Sub: Corrigendum-07: Issuance of Clarification, amendment and Extension of offer submission due date.

Scope of Work: CHP STRUCTURE ERECTION AT 3X800 MW PVUNL PATRATU, JHARKHAND.

OWNER	NTPC LIMITED		
CUSTOMER	BHEL		
PROJECT	3 X 800MW, Patratu Super Thermal Power Project, Stage – I, Jharkhand		
Title	Conveyor Profiles for CHP, LHP, GHP	DATE	12-Mar-19
Doc NO.	IS-1-GA-717-101-M009	REV	1
Sl. No.	NTPC Comments	Clarifications

SHEET NO. 5		NO.OF SHTS. 6		REV. 02

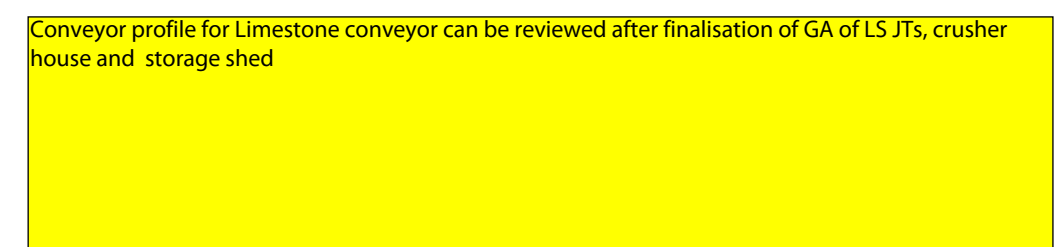
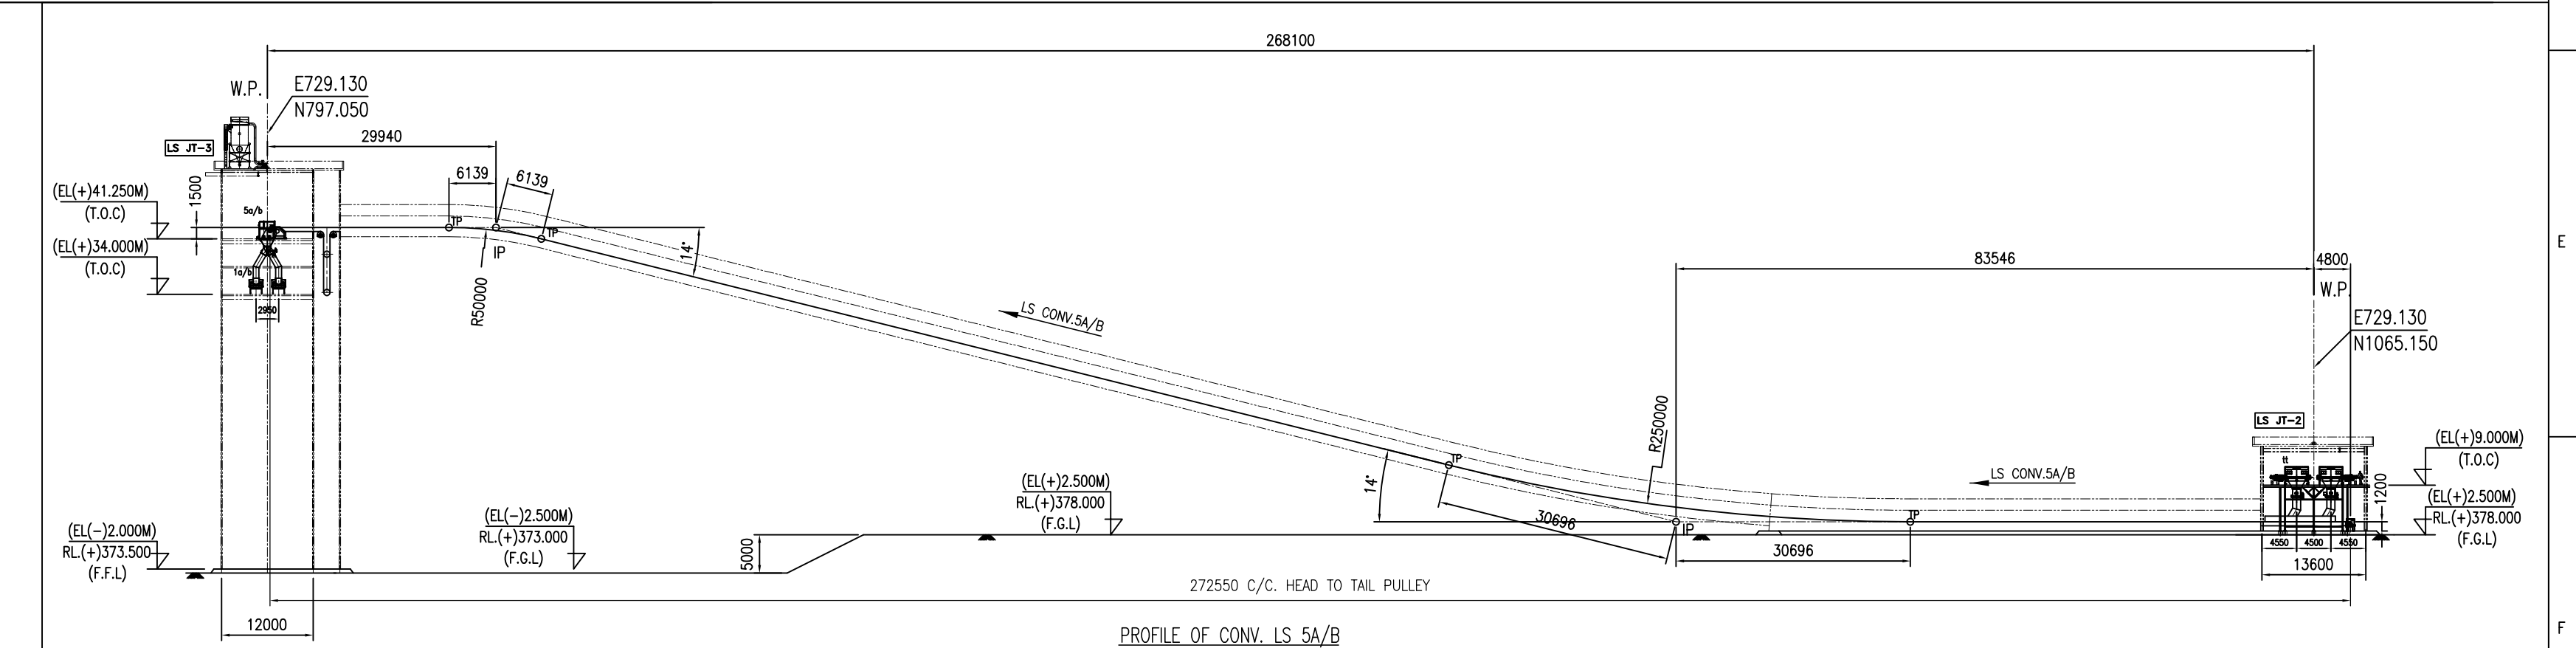
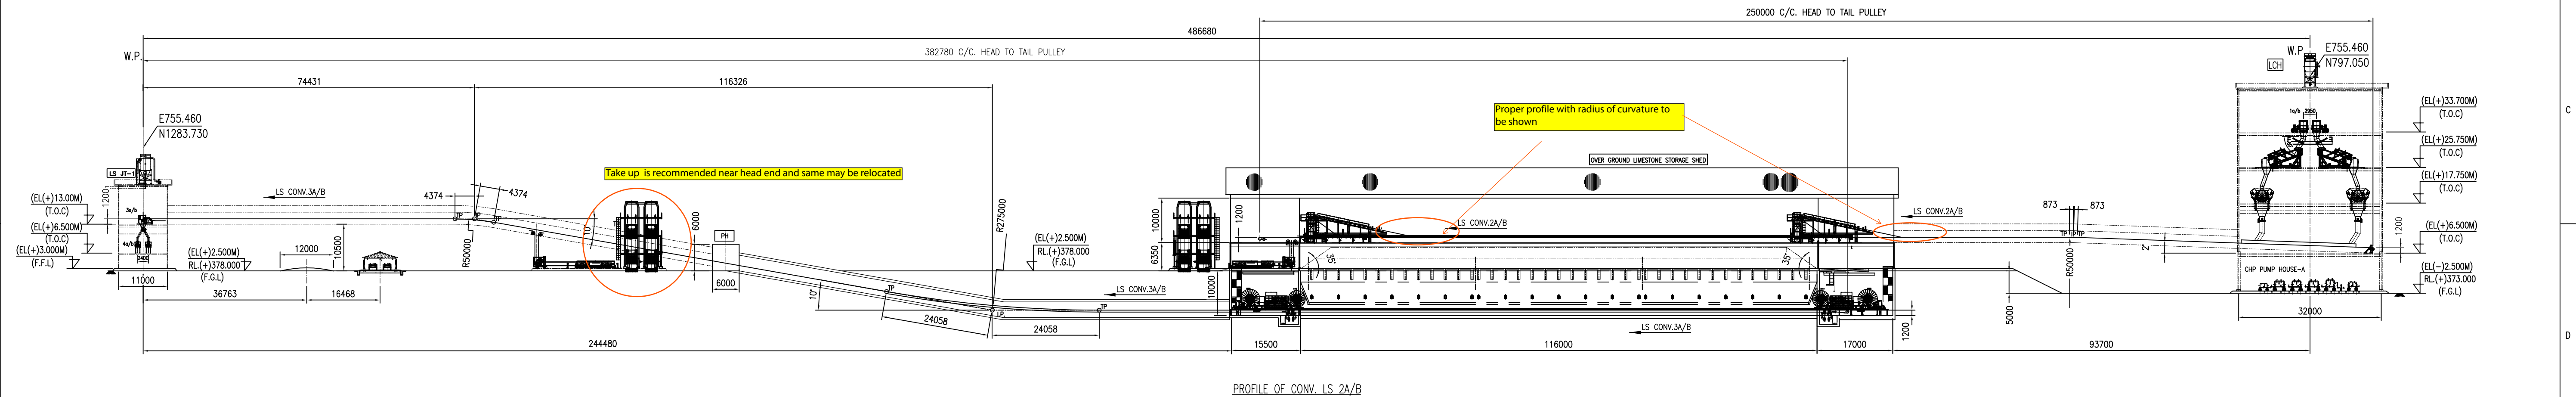
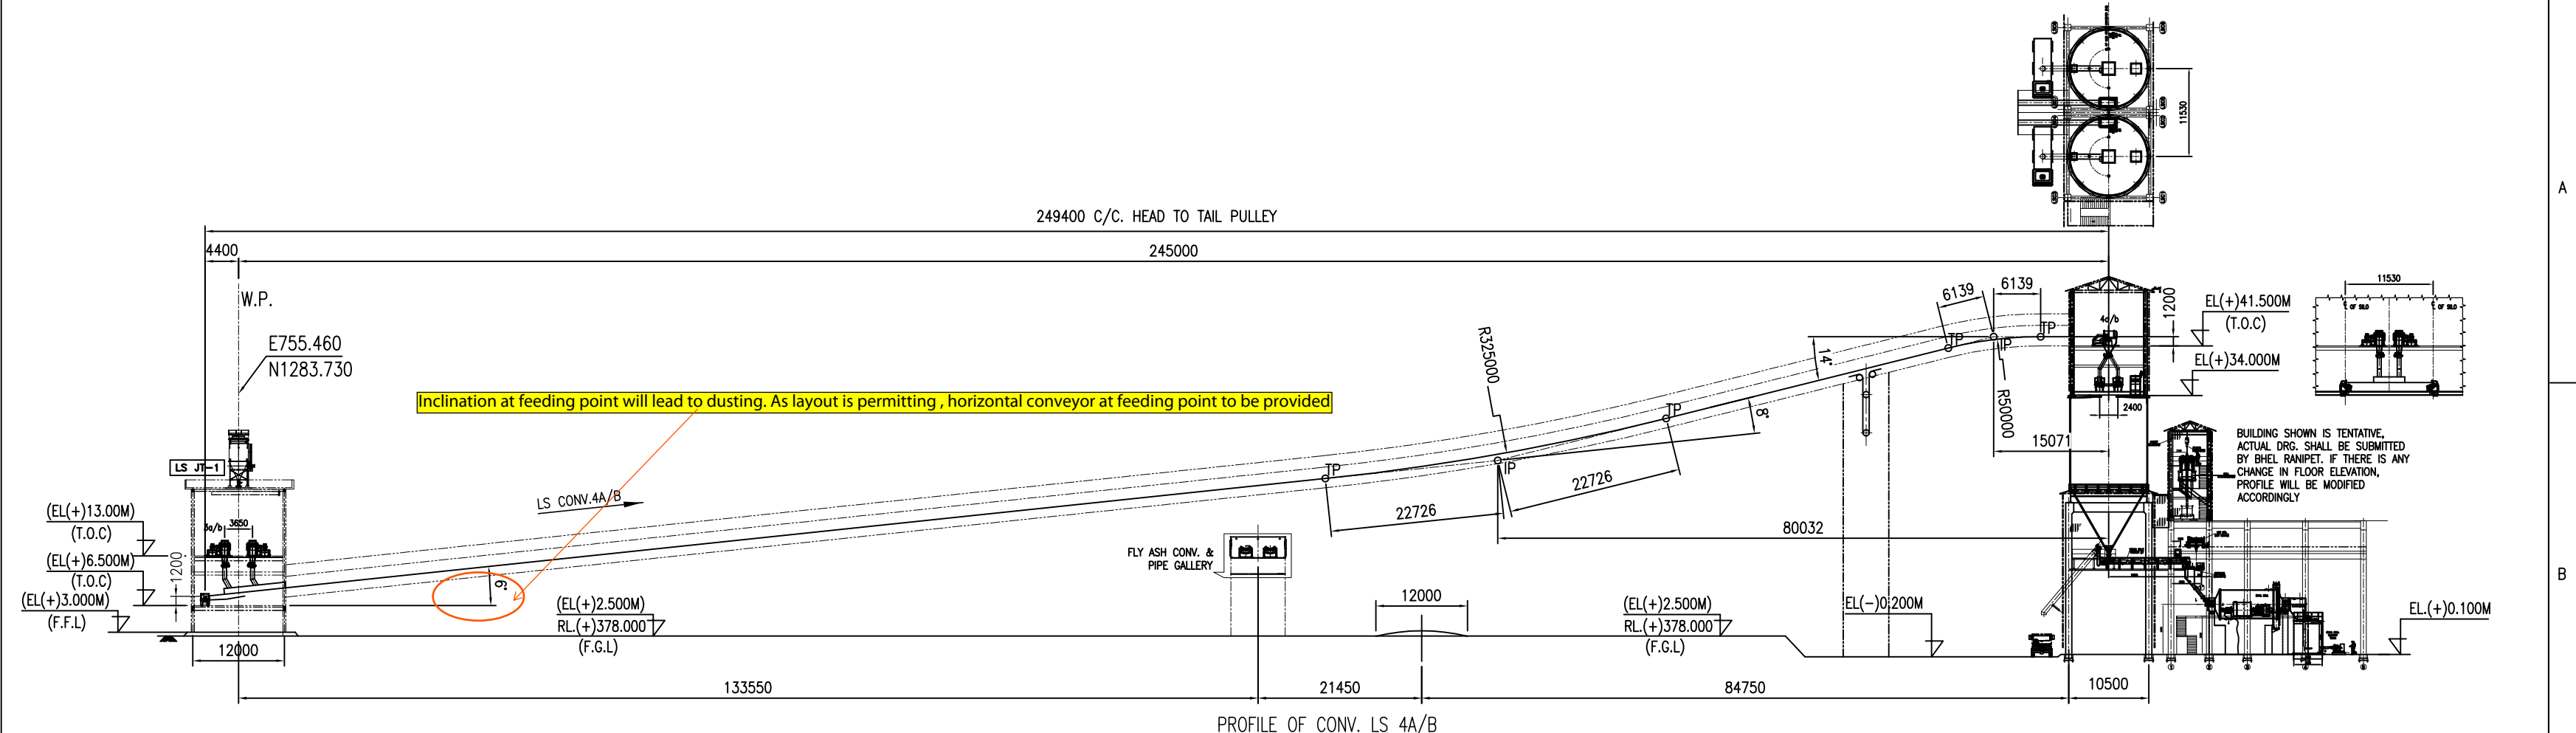
Single line flow diagram of GHS is not yet finalised, hence layout is also not yet finalised. Further conveyor profile can be reviewed after finalisation of JTs and stock pile details

Sheet 5 of 6			
1	REFER COMMENTS ON SHEET 2	Revised accordingly	
2	GTU within TP at feeding point is not acceptable.	Revised location	
3	Provide T/U nearer to head end	Due to more travel length, it is kept away from the road.
